SSD 1072865 - Redfern Mixed Use Boarding House Development – Advice on EIS

Thank you for your correspondence dated 26 October 2021 inviting the City of Sydney Council (“the City”) to comment on the proposed State Significant Development (SSD) application for a new boarding house at 175 Cleveland Street, 177 Cleveland Street and 1-5 Woodburn Street, Redfern.

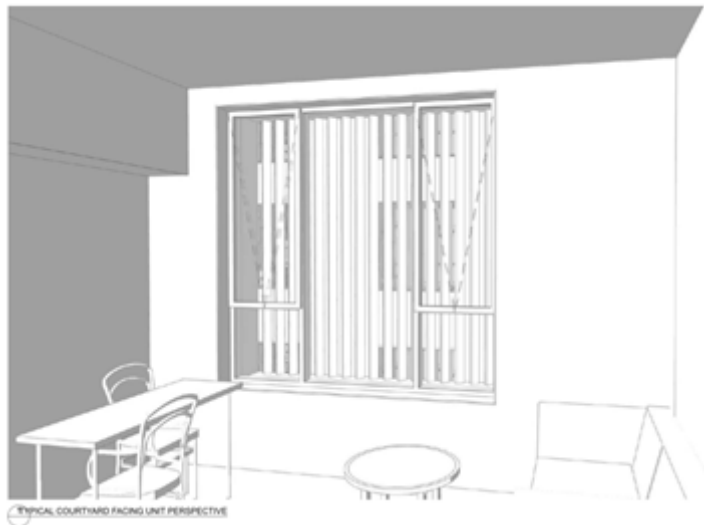
- **Visual and Acoustic Privacy:** The small courtyard provides the only outlook for 47 rooms: 11 rooms per floor on L1/L2, 10 rooms per floor L3/L4, 5 for L5. The multiple visual and acoustic privacy issues this layout creates horizontally and vertically combined with the lack of any sun for 38 of these rooms mid-winter results in poor residential amenity. The reliance upon privacy screening may mitigate some visual privacy concerns, but not acoustic, and comes at the expense of outlook amenity from each of the rooms only window and shown in a submitted perspective drawing (below) accompanying the application.

- The size of the courtyard is to be increased to improve the amenity of rooms reliant on this aspect (a 12m separation as per the ADG is recommended).
- The courtyard is to be designed to receive some sunlight mid-winter.
- Operable external privacy treatments are recommended to courtyard rooms to enable user-controlled privacy and solar access to those rooms that can receive it.
- Alternative attenuated ventilation to noise affected facades is recommended in addition to requiring all windows have an operable element for purge ventilation.
- Increased room frontages are recommended to enable some room layout flexibility & circulation around beds – type D, E and F layouts are not supported.
- All rooms are to meet the minimum ARH SEPP area requirements which accurately factor in allowances for kitchens including circulation where it is not part of essential room circulation.
